CONSOLIDATED EDISON COMPANY OF NEW YORK, INC.
INDIAN POINT NUCLEAR GENERATING UNIT NO. 3

FIRST SUPPLEMENT TO:
PRELIMINARY SAFETY ANALYSIS REPORT

PREFACE TO QUESTIONS

Supplement 1 of the Indian Point Unit No. 3 PSAR consists of responses to the Atomic Energy Commission's letter of February 19, 1968, and July 1, 1968.

FIGURE C-2
SUPPLEMENT 1

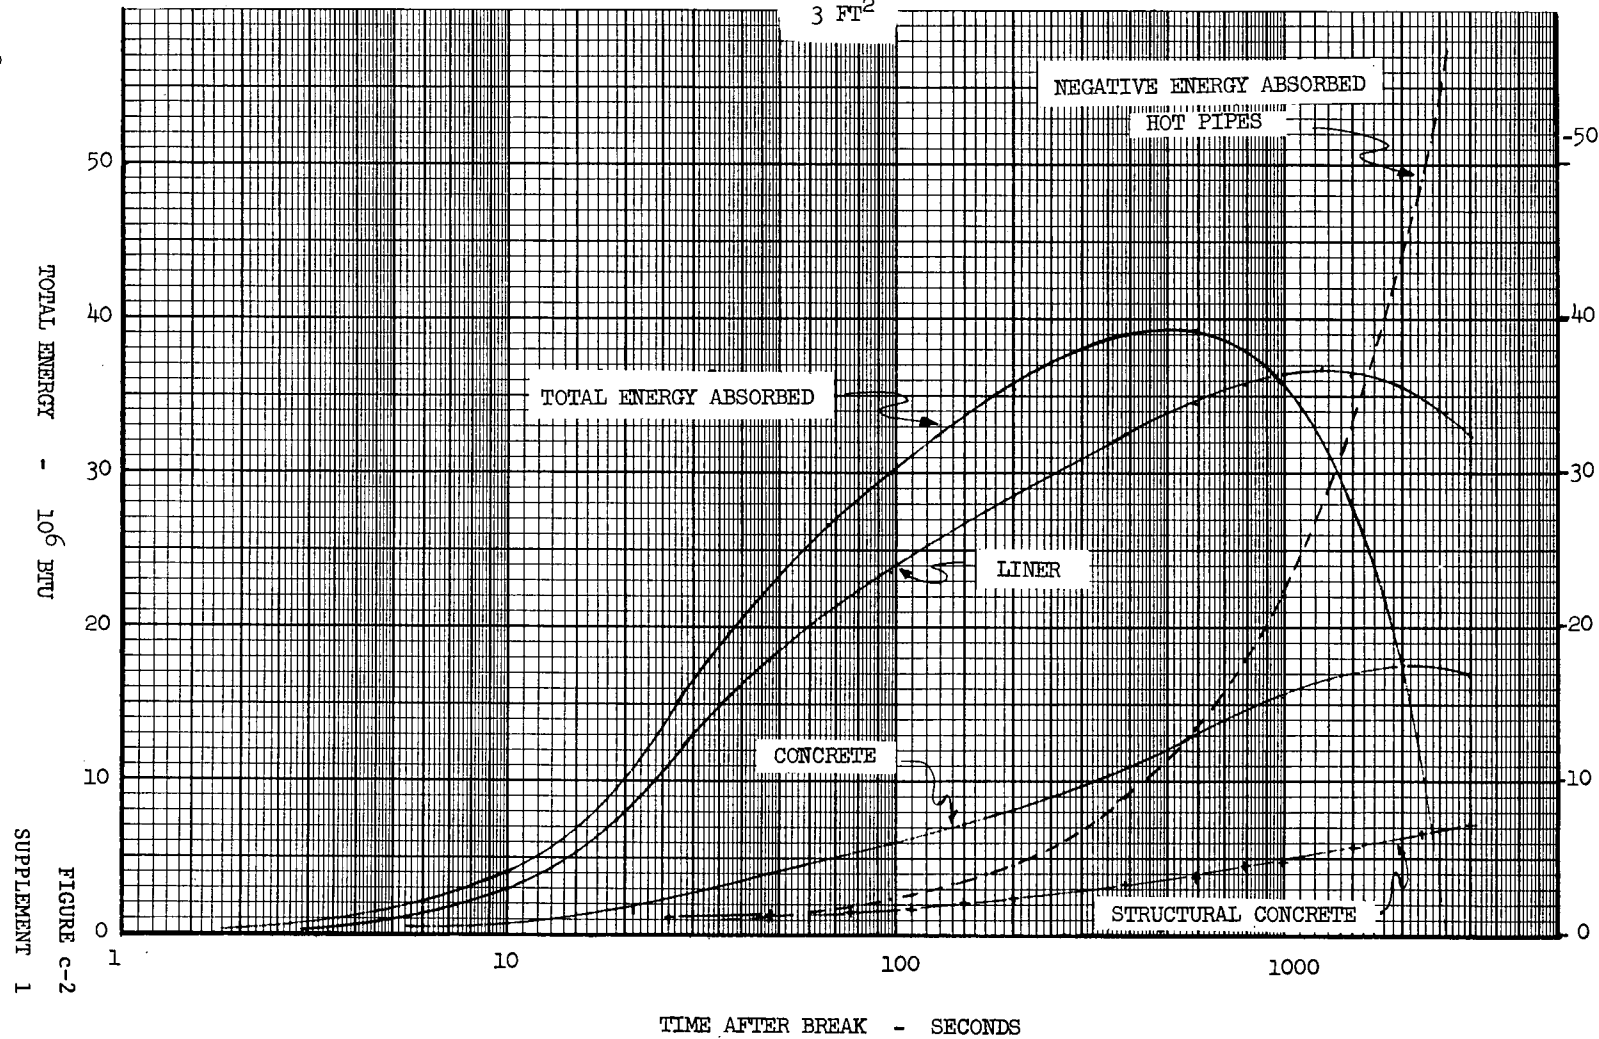
The integrated energy absorbed by the various structural heat sinks is presented in Figure c-2.

FIGURE c-3
SUPPLEMENT 1

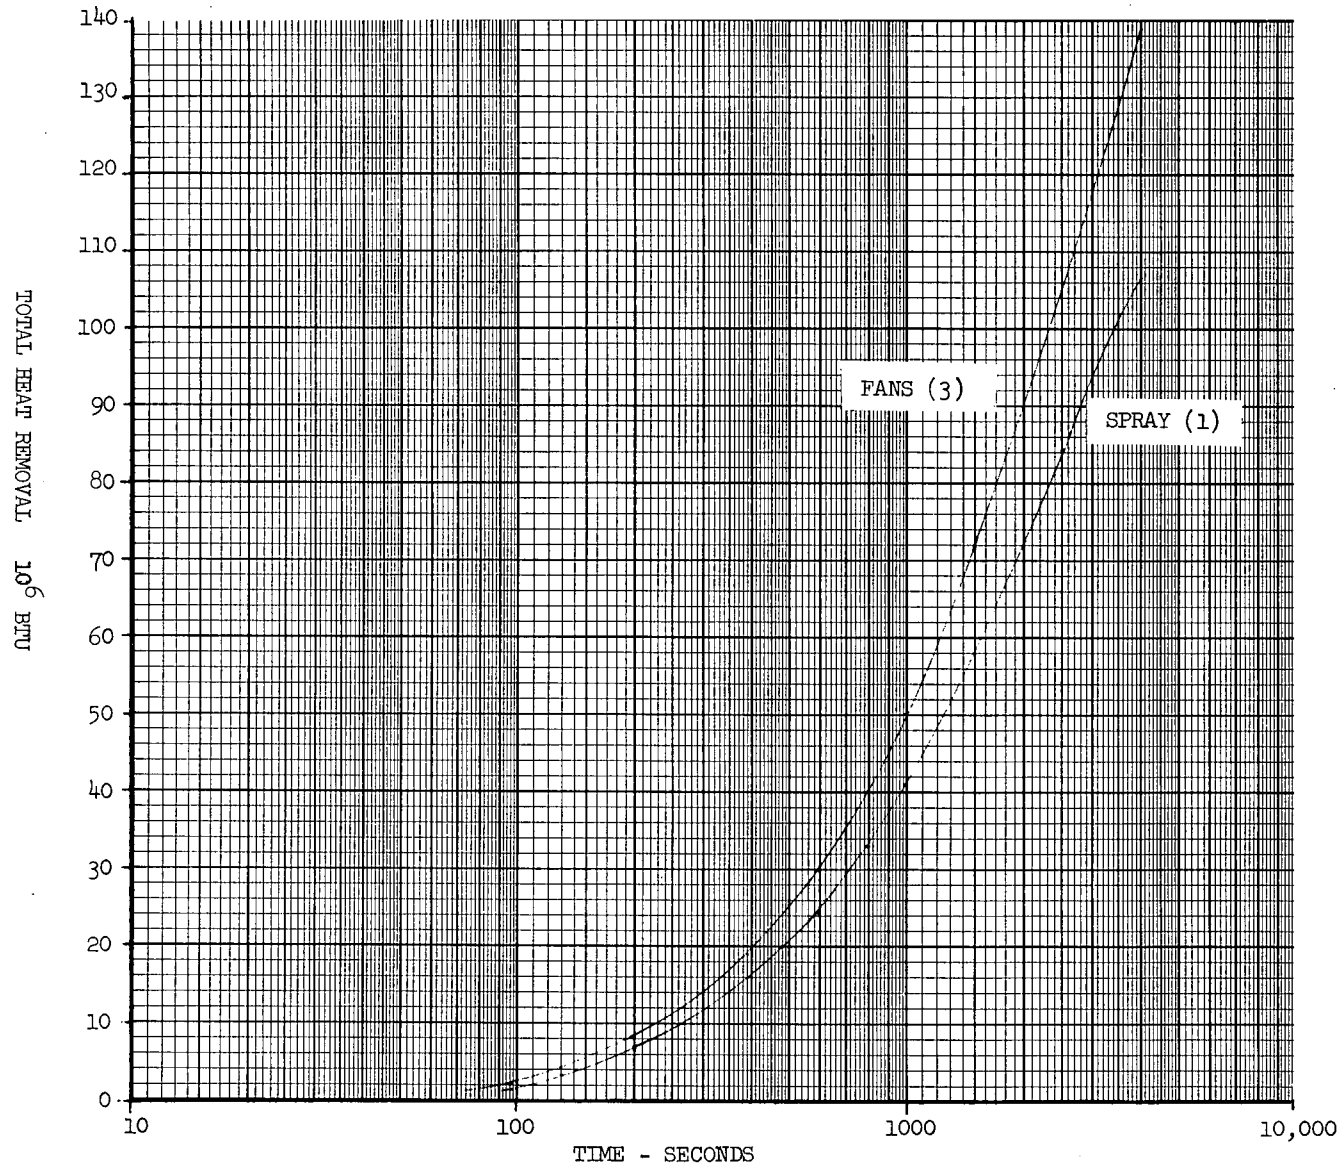
The active heat removal source (fans and sprays) do not contribute to the heat removal before the peak containment pressure is reached. The total integrated heat removal for the fans and spray is presented in Figure c-3.
